BREWERS HILL LOT 6C | BALTIMORE, MD.

UDARP PRESENTATION - FIRST FINAL

FIRST FINAL | JANUARY 12, 2017

07/28/2016 UDARP COMMENTS + TEAM RESPONSES

CURRENT DESIGN

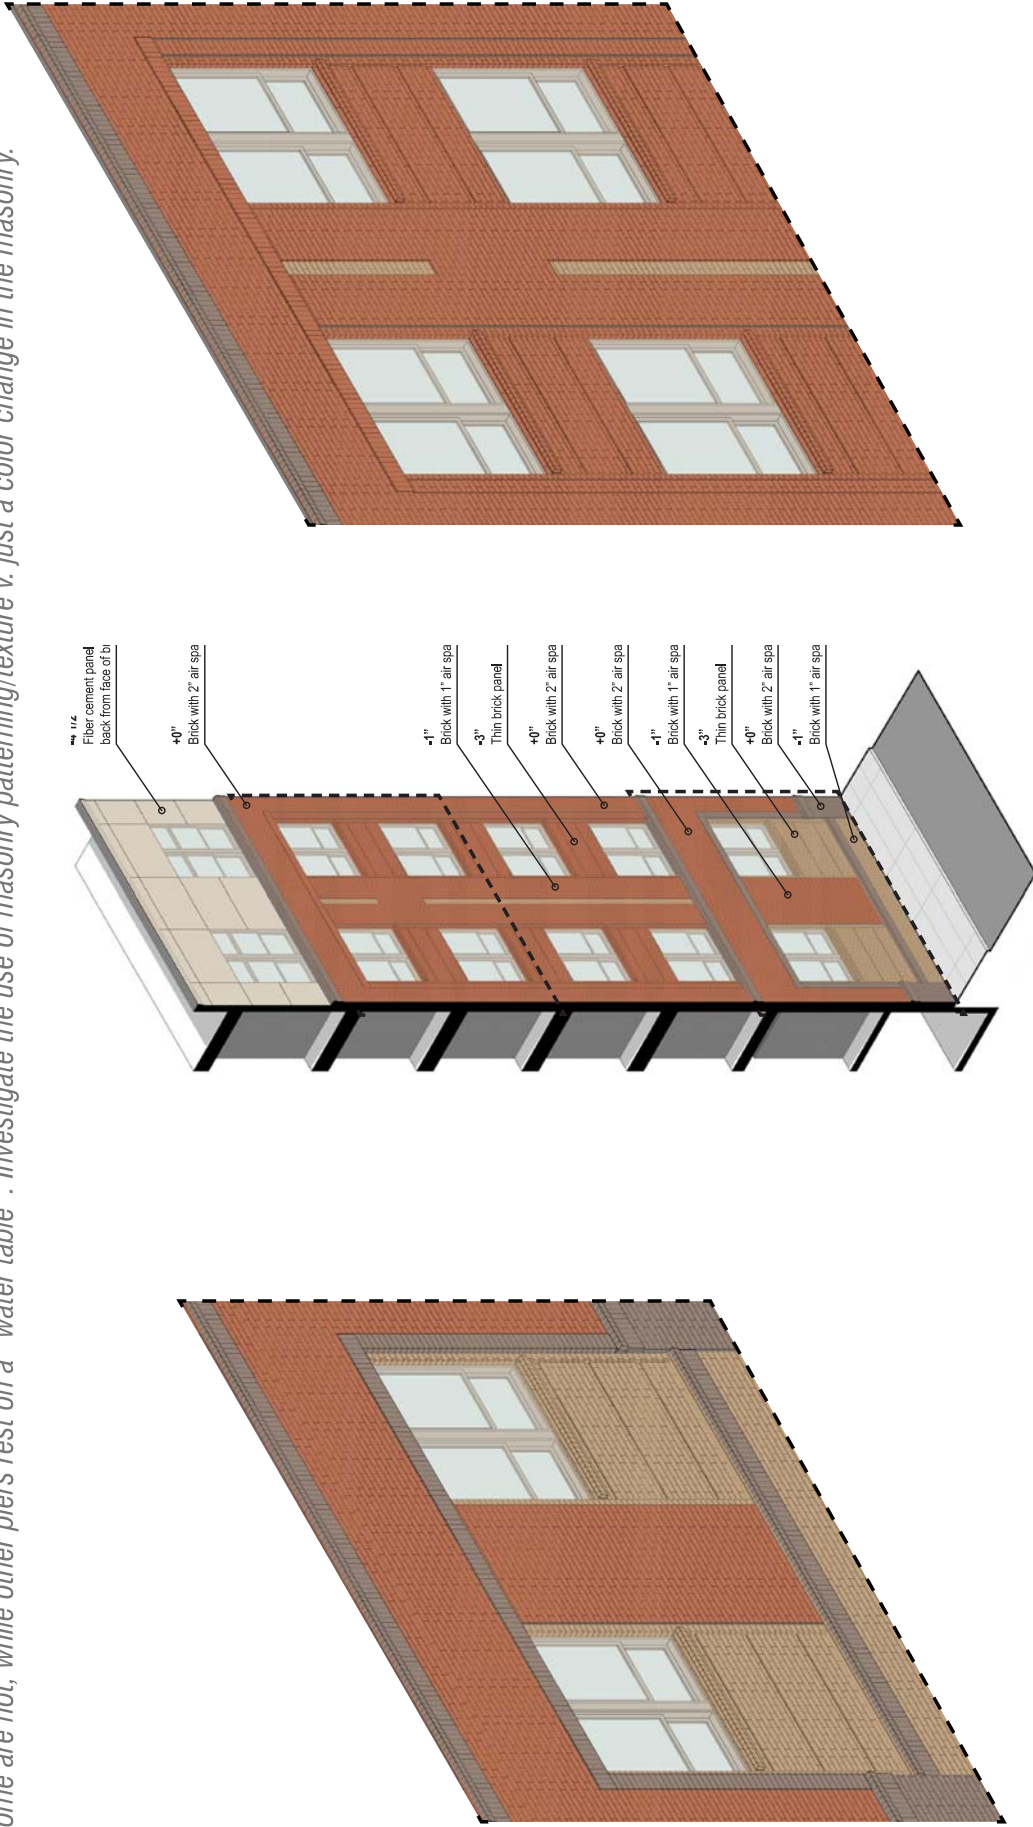
ARCHITECTURE #3 -

Restudy the treatment of the masonry piers at the base of the building to establish a consistent design intent. Currently some piers are rooted to the ground plane, some are not; while other piers rest on a "water table". Investigate the use of masonry patterning/texture v. just a color change in the masonry.

PREVIOUS DESIGN -
07/28/2016

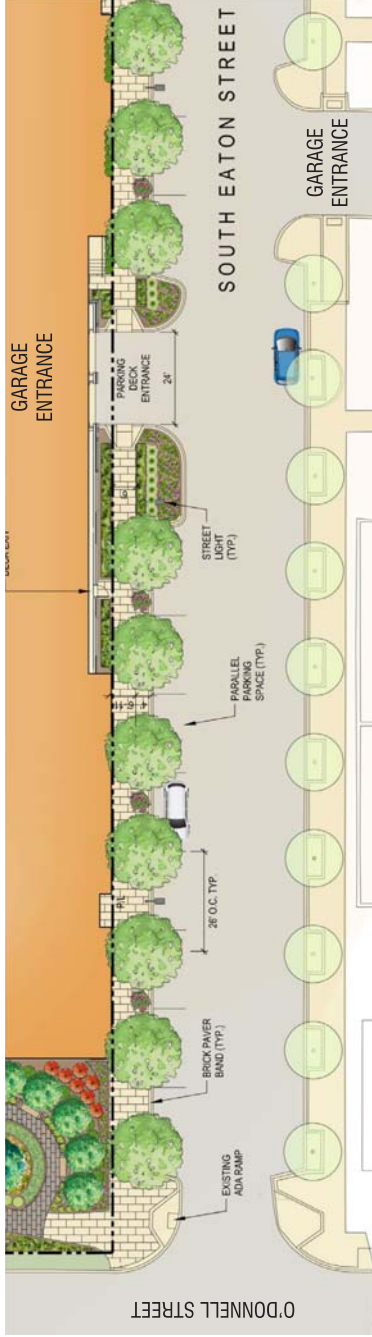
URBAN DESIGN/STREET SCAPE #2 -

Continue to study ways in which landscape and architecture can improve the pedestrian experience the north end of South Eaton Street.

WALKING SOUTH ALONG SOUTH EATON STREET

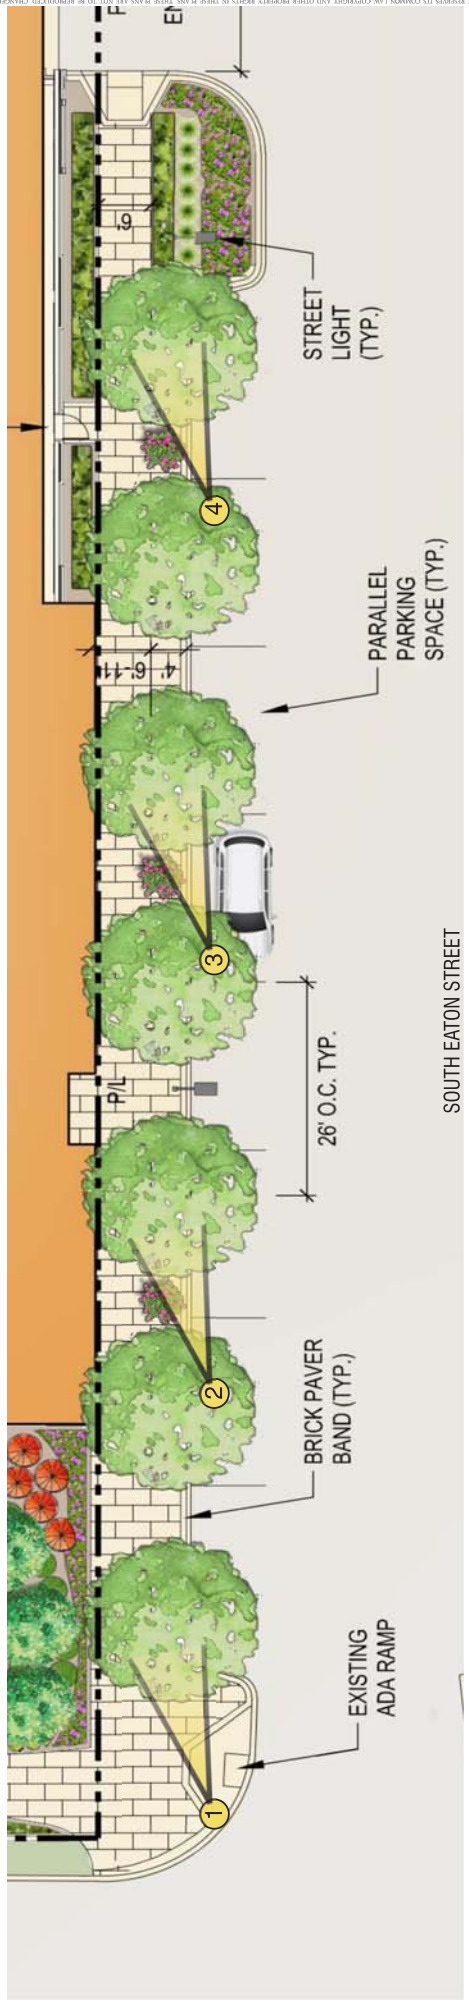
URBAN DESIGN/STREET SCAPE #2 -

Continue to study ways in which landscape and architecture can improve the pedestrian experience the north end of South Eaton Street.

CURRENT DESIGN

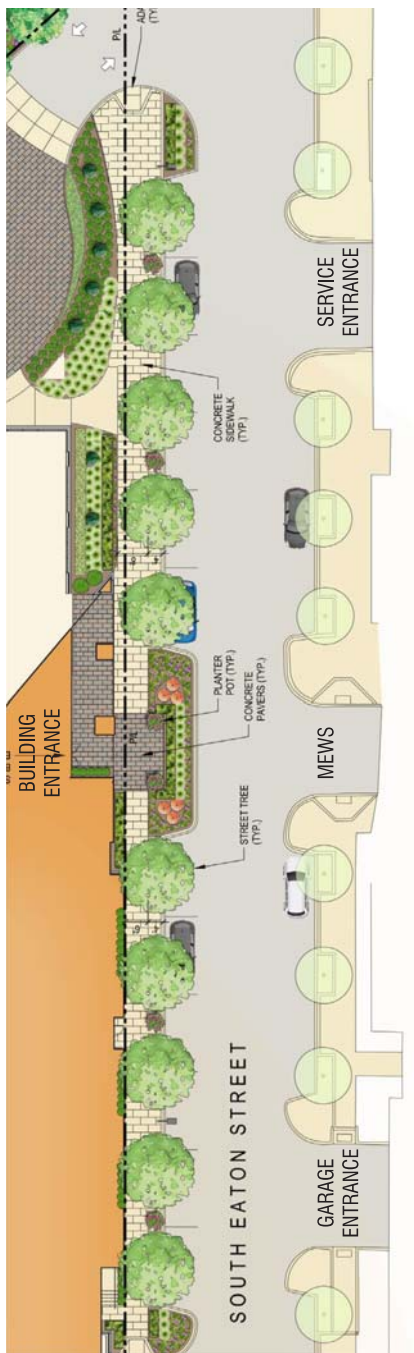
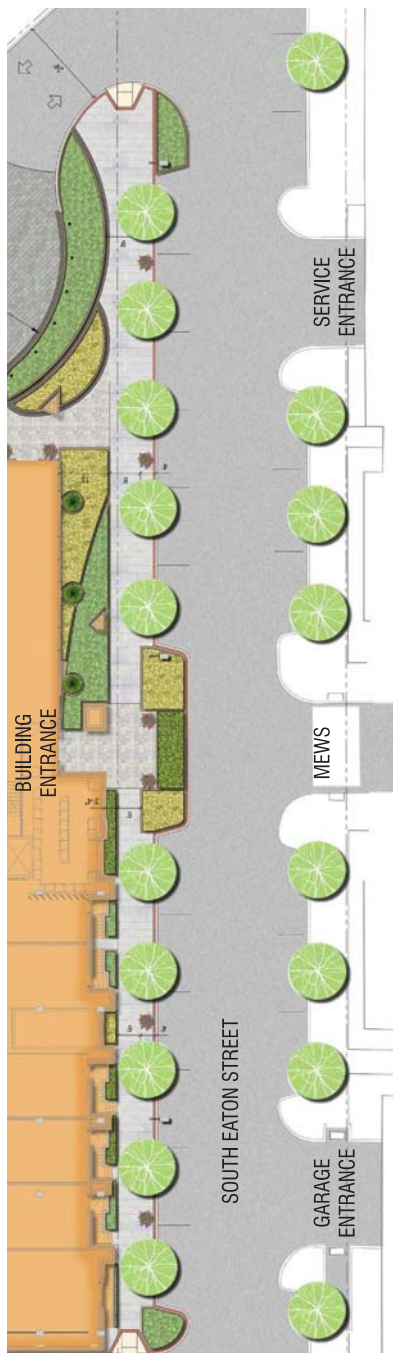
URBAN DESIGN/STREET SCAPE #3 -

Continue to study ways to safely direct pedestrian mid-block movement across South Eaton Street.
